REQUEST FOR CONSTRUCTION CONTRACT CHANGE CHANGE ORDER NO. 3

City of Franklin
Engineering Office
109 Third Avenue South
Franklin, Tn 37064

Contract Number: 2017-0264
Project Name: Water Reclamation Facility
Modifications & Expansion

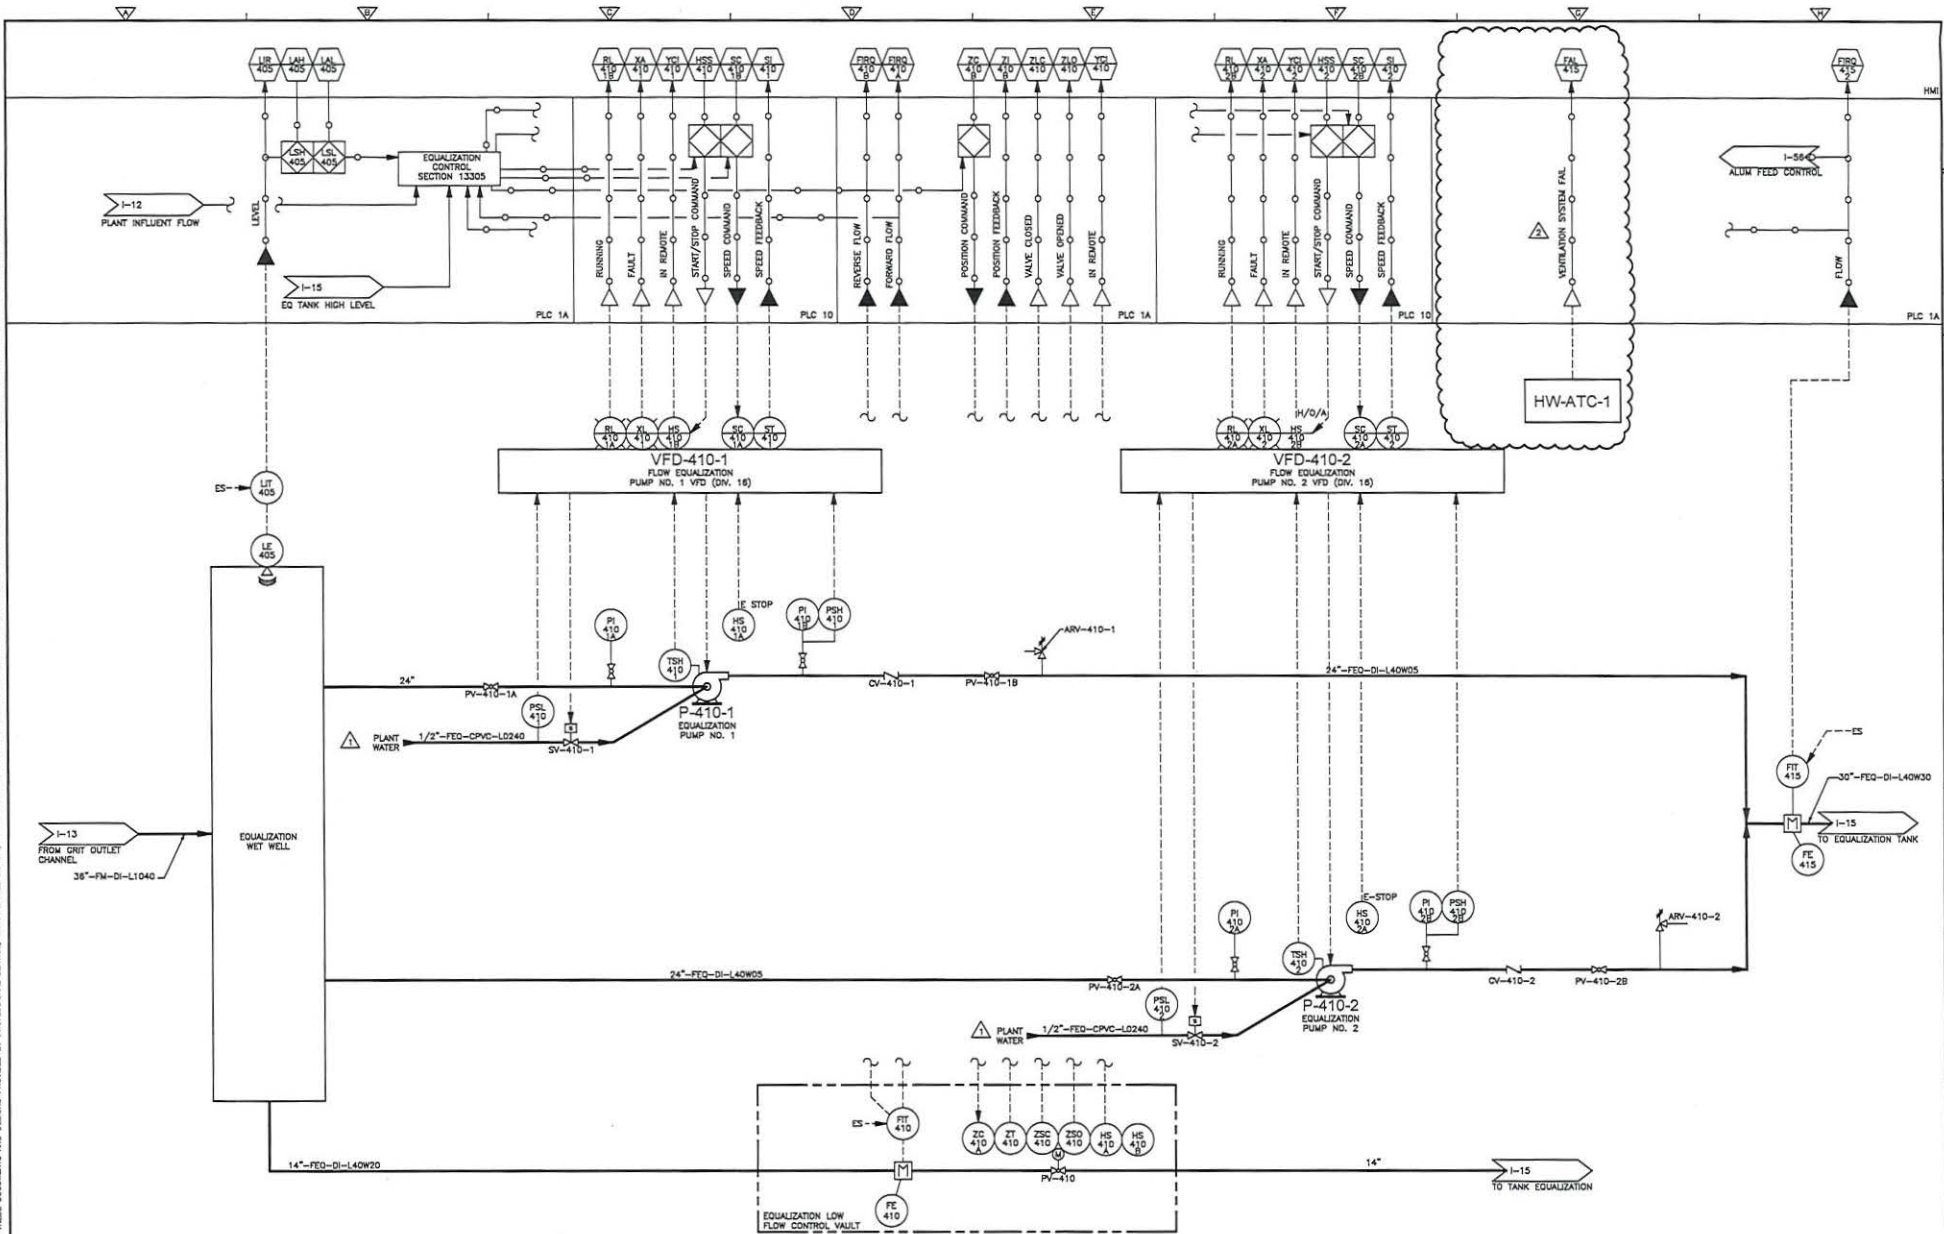
DESCRIPTION: Sheets H-3, H-9, H-11, H-14 and H-15 show remote indication of ventilation failure signals from affected ATC panels, but these signals were not shown on I&C drawings. Sheets I-14, I-19, I-24, I-25, I-44 and I-55 attached hereto are amended to reflect these signals.

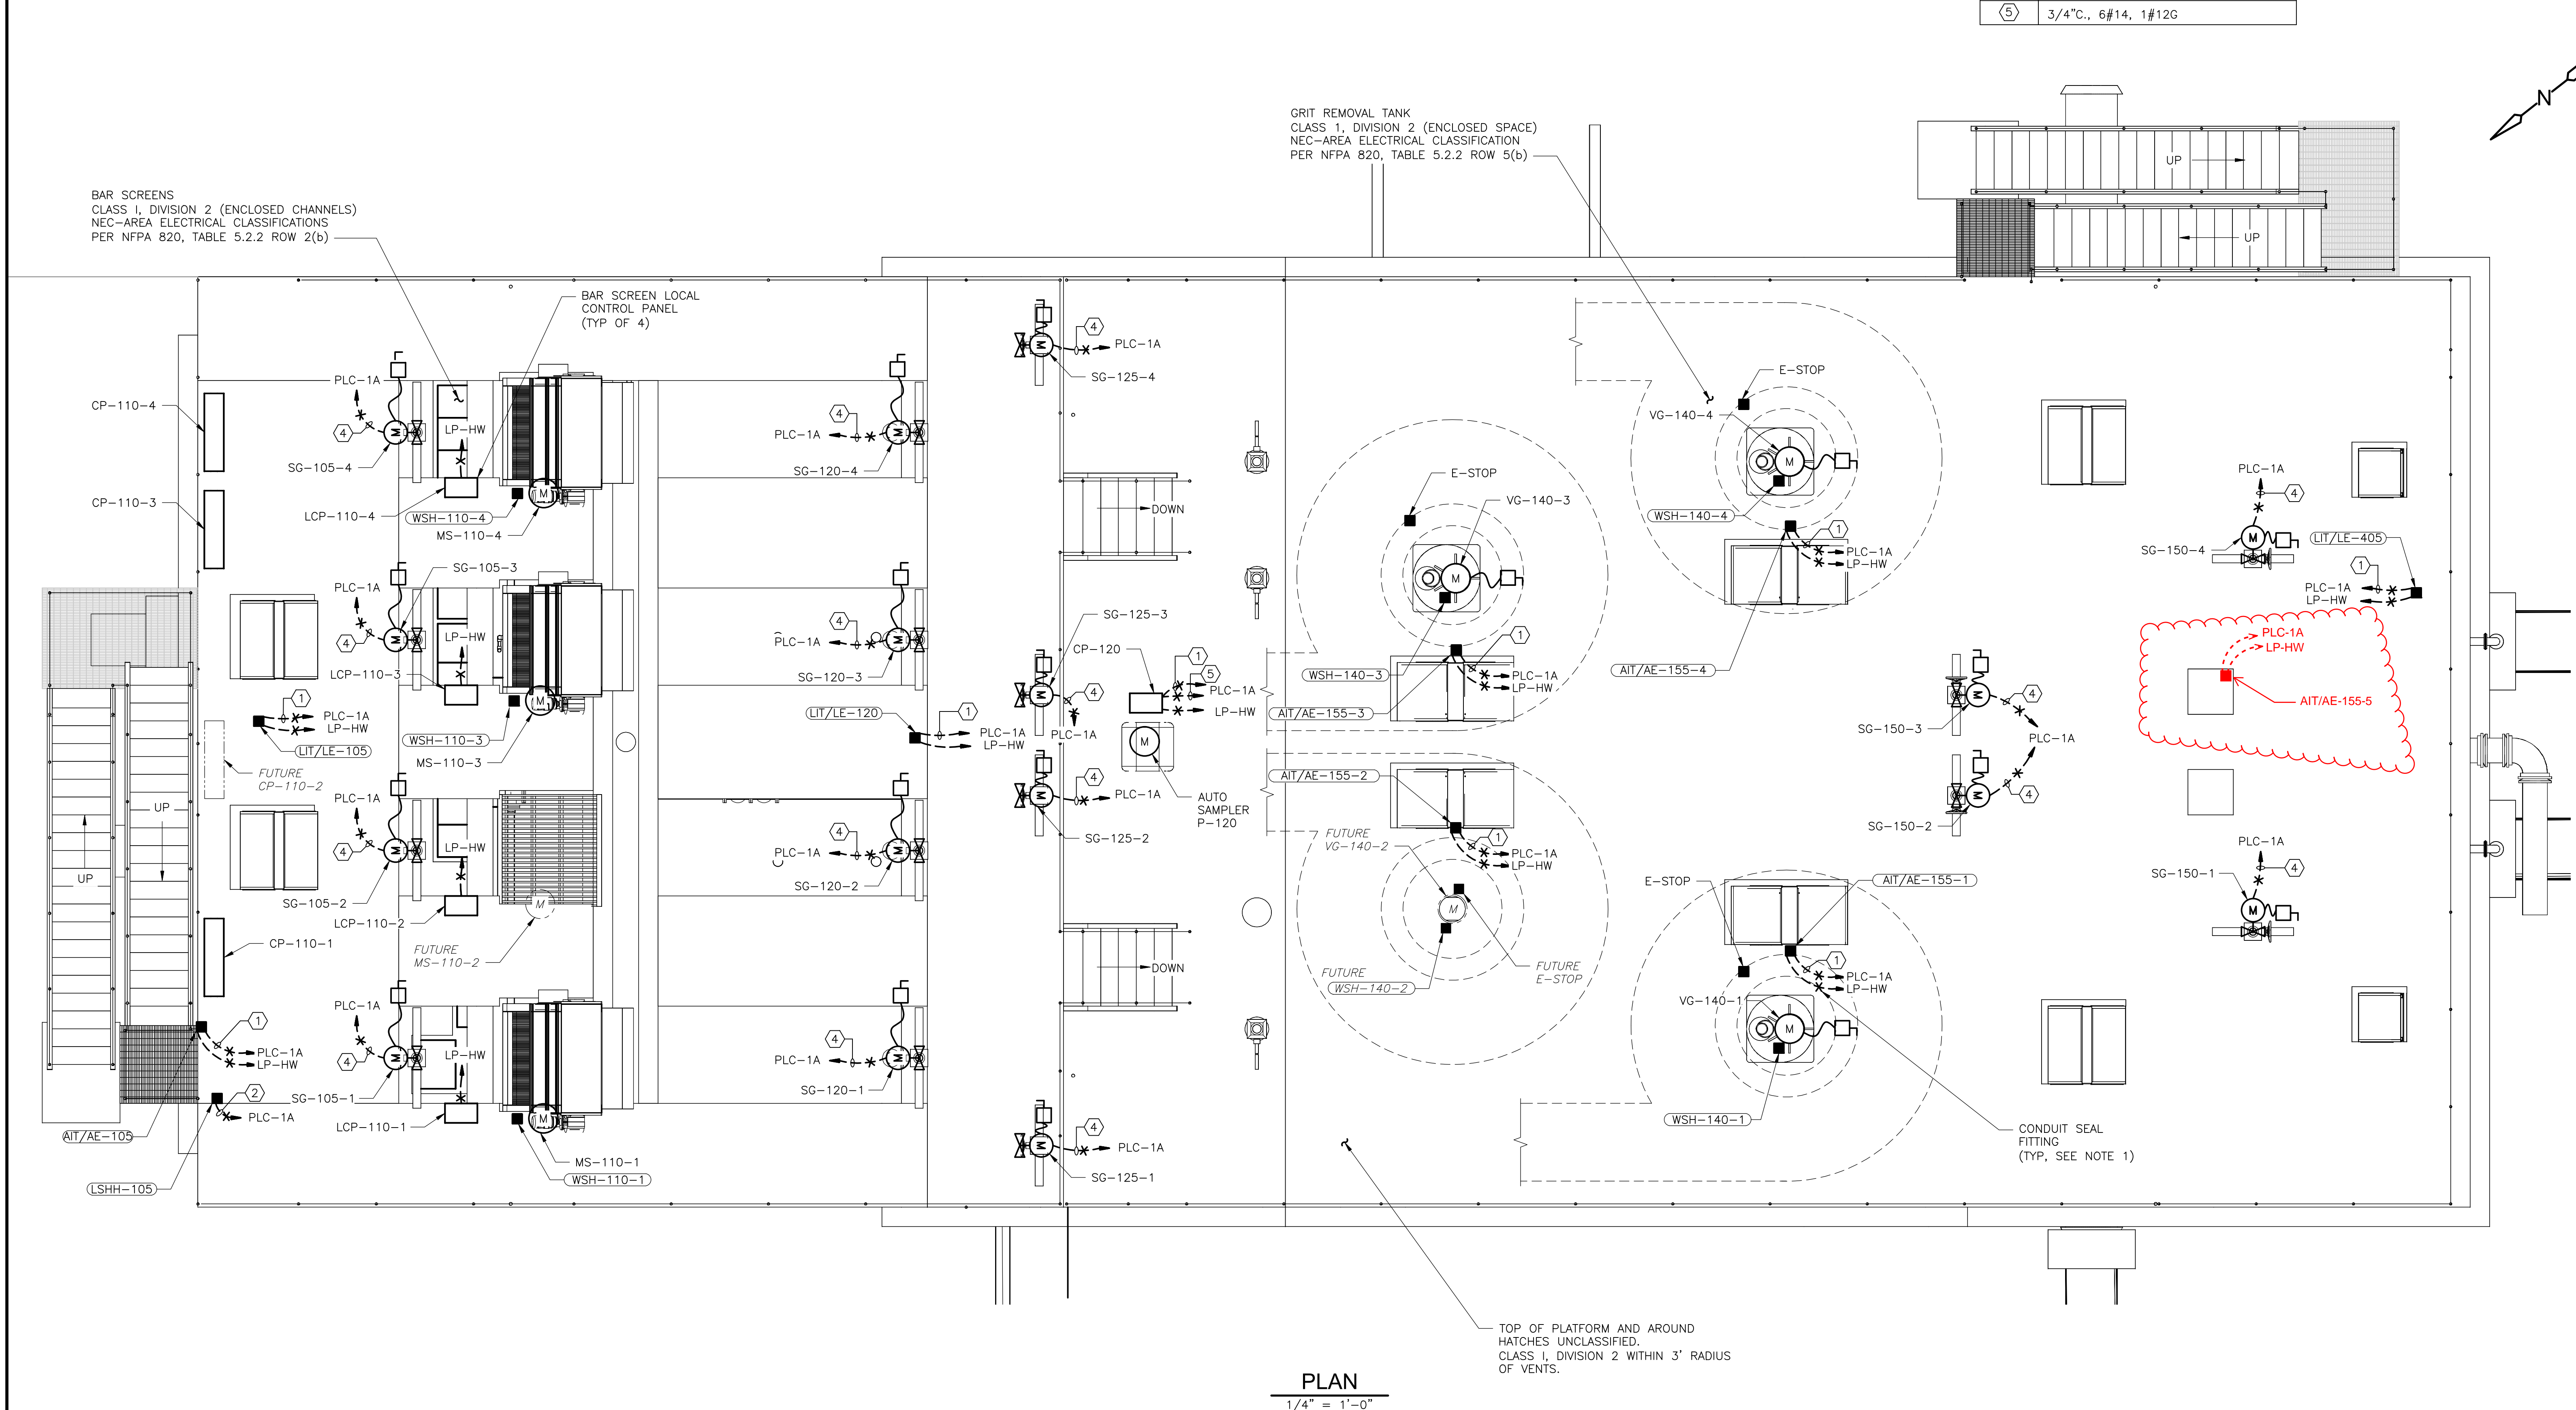
Spec Section 13340, 2.22.D. lists AE/AIT 155-5 (Grit Outlet Channel) and AE/AIT 450 (EQ Odor Control). AE/AIT 155-5 is not shown on I-13, E-60 or 61. AE/AIT 450 is shown on I-17 but not on E-79. Please clarify location of these detectors.

See attached Electrical Drawing E-61 with the location of combustible gas detector AE/AIT-155-5. The AE sensor shall be located in the grit channel space below the 2' x 2' hatch. Use Circuit #37, Spare 20A/1P circuit breaker, in Panelboard LP-HW.

The combustible gas detector (AE/AIT-450) is not required at the Equalization Odor Control in accordance with the NFPA 820 hazardous area classification sited on Electrical Drawing E-79. Provide credit proposal for removal of combustible gas detector.
